DOCKET ITEM #6

Development Site Plan #2014-0024 Special Use Permit #2014-0088 5055 Seminary Road – Southern Towers Clubhouse and Day Care Center

Purpose of Application

Figure 7: Possible location of future high-capacity transit stop

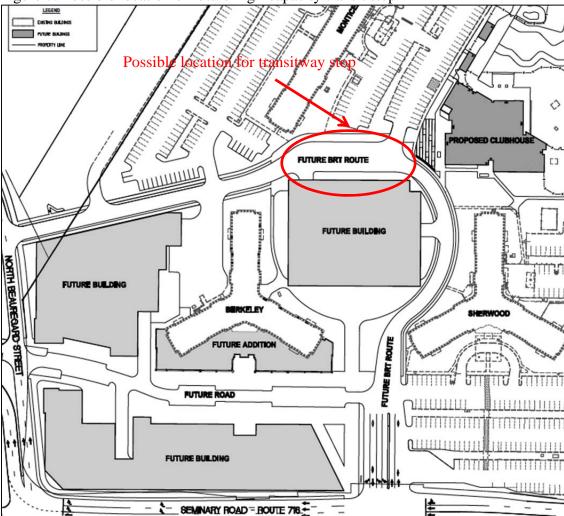
The site of the proposed clubhouse lies directly adjacent to a planned, high capacity, transit stop for the "Corridor C" transitway route. The clubhouse structure and site configuration will not impede the future construction of the transit stop. Additionally, staff worked carefully with the applicant to design the day care center pick-up and drop-off arrangement such that it would not conflict with the future bus routes. As proposed, the main door of the clubhouse will open towards the location of the proposed transit stop.

- F-2. Construction of the West End Transitway will impact a limited portion of the plaza proposed for the front of the clubhouse. (T&ES-Transit)
- F 3. Since the record drawings, maps, and other documents of the City of Alexandria, State, and Federal agencies show the true north pointing upwards, therefore, the Site Plan shall show the true north arrow pointing upward as is customary; however, for the sake of putting the plan together and/or ease of understanding, the project north arrow pointing upward, preferably east, or west may be shown provided it is consistently shown in the same direction on all the sheets with no exception at all. The north arrow shall show the source of meridian. The project north arrow pointing downward will not be acceptable even if, it is shown consistently on all the sheets. (T&ES)
